**Subject: *As built* for the landscape remediation and restoration construction project  
for the area designated "Àrids Catalunya", Cerdanyola del Vallès.**

Inf. File: 07/2069, SC-427/2

<b>Technical report on the evaluation and assessment of the work carried out on the landscape restoration (green corridor) for the area designated “Àrids Catalunya”, within the framework of information file No. 07/2069, SC-427/2</b>	
<b>Description: <i>As built</i> for the landscape remediation and restoration construction project for the area designated “Àrids Catalunya” partial Plan by the Centre Direccional de Cerdanyola del Vallès</b>	
<b>City: Cerdanyola del Vallès</b>	<b>Date: 15/10/12</b>

ANNEX 1. Plan 1. Area for asbestos waste confinement with UTM coordinates:

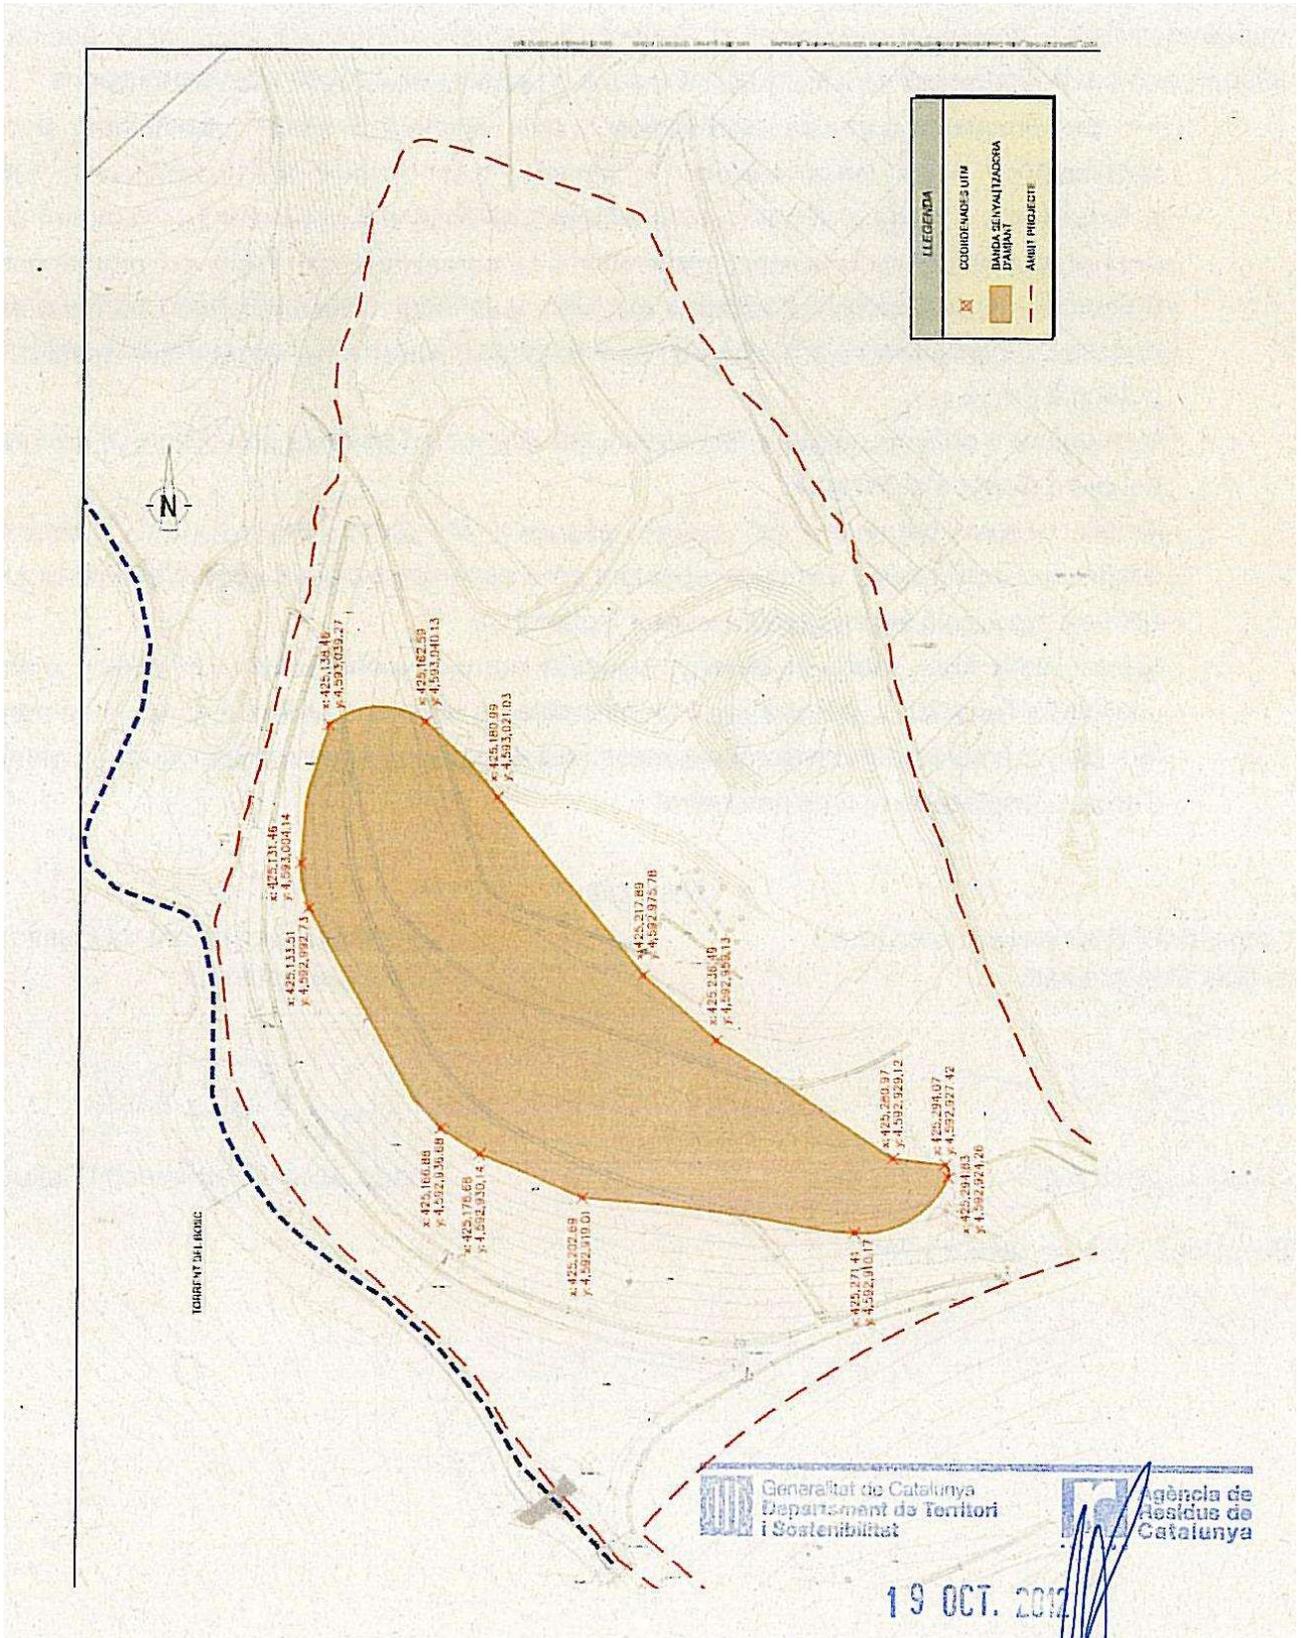
- Not to prepare the area of asbestos waste confinement delimited by the UTM coordinates (see Annex 1 Plan 1) for it to be put to agricultural use, corresponding to the right side of the road, easily identifiable at present and with a steeper slope than that of the rest of the land. The maintenance work on this area of land can also be carried out without the need of agricultural machinery to cultivate the land. To assess whether it is necessary to provide topsoil to reach a depth of 50 cm.
